<sup>670</sup>  
**PETITION TO THE CITY COUNCIL**

For permission to place metal posts as shown on plan supplied.  
The purpose being the prevention of cars jumping the sidewalk  
and hitting our building and the windows. Also wish to avoid  
any vehicles parking on this sidewalk as it is a vault area.

Subject: Erection of Metal Posts Along Empire Street Curb Line  
Petition Filed by William H. Harris Furs

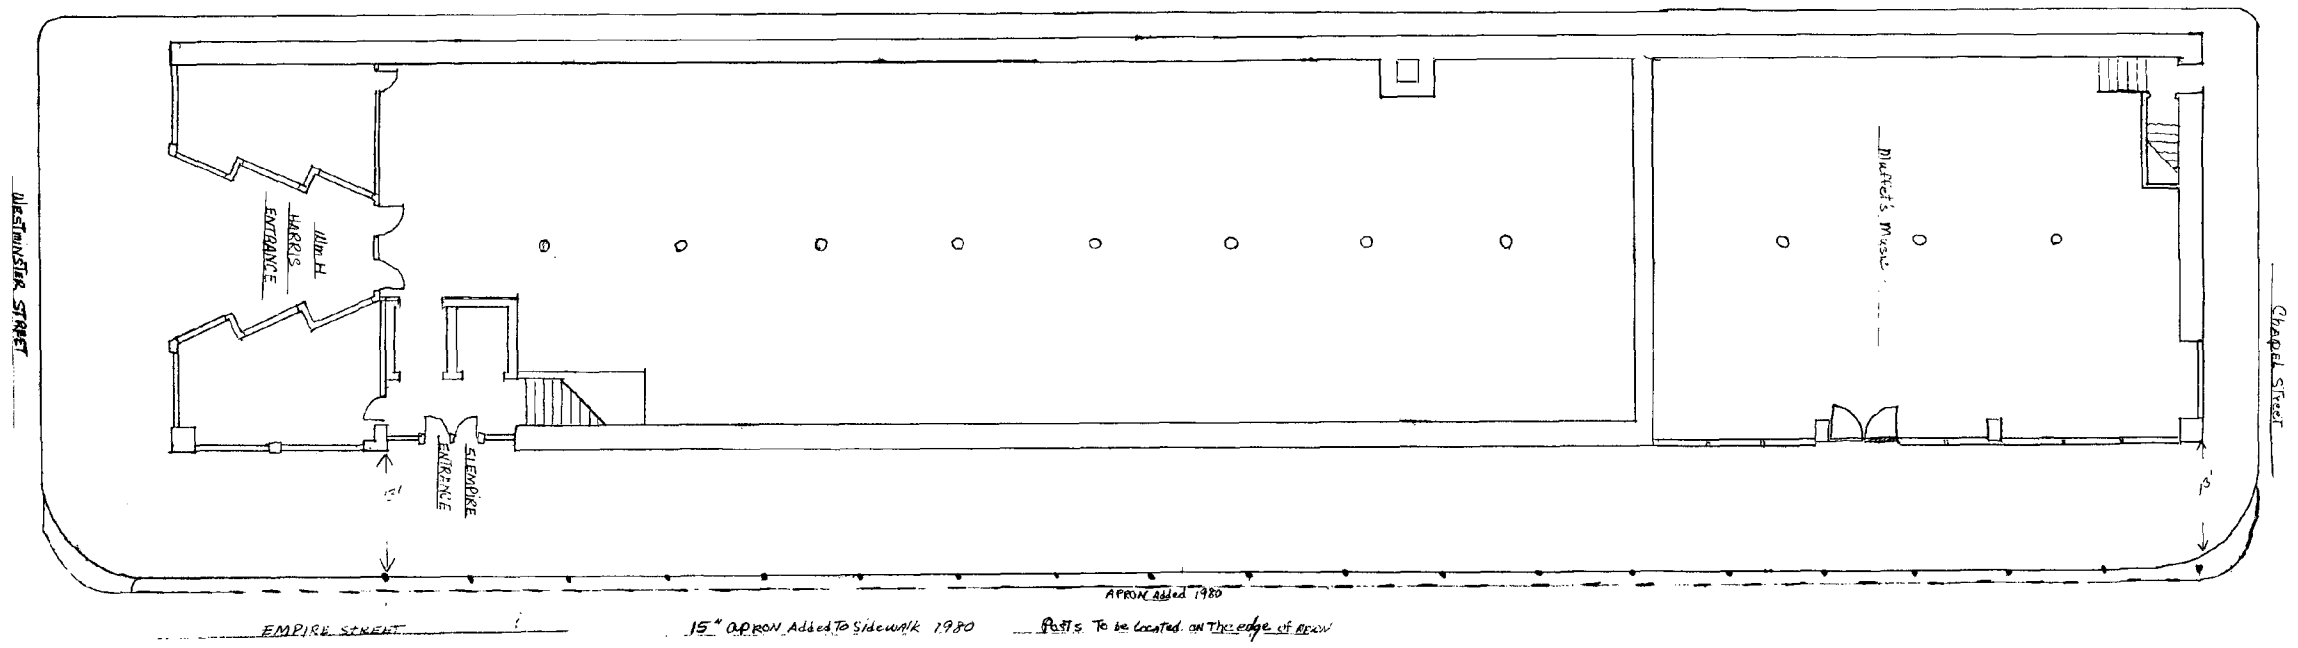
The intent of the proposal is to eliminate the possibility of a truck or car parking on the sidewalk in this area whether for deliveries or by accident. This in effect will eliminate any possible real tragedy from occurring should a car or truck fall through the sidewalk and injure or kill someone working below. This is by no means the proper measure to correct the situation. It will certainly not stop the leaking of the water and further deterioration of the beams and will only eliminate one possible hazard from occurring.

Should this council approve this petition, I would recommend that a sample of the type of post be shown to both the Department of Building Inspection and the Department of Planning & Urban Development because if this treatment is not done properly it could have a negative effect on the opposite side of Empire Street, which is almost totally new construction. Should the post be acceptable to both these Departments I would only recommend an approval for six months, at which time Mr. Harris should be forced by either the courts or by the City Council to properly repair his sidewalk or to fill the vault in altogether.

I strongly recommend that the petition in its present form be held for further study.
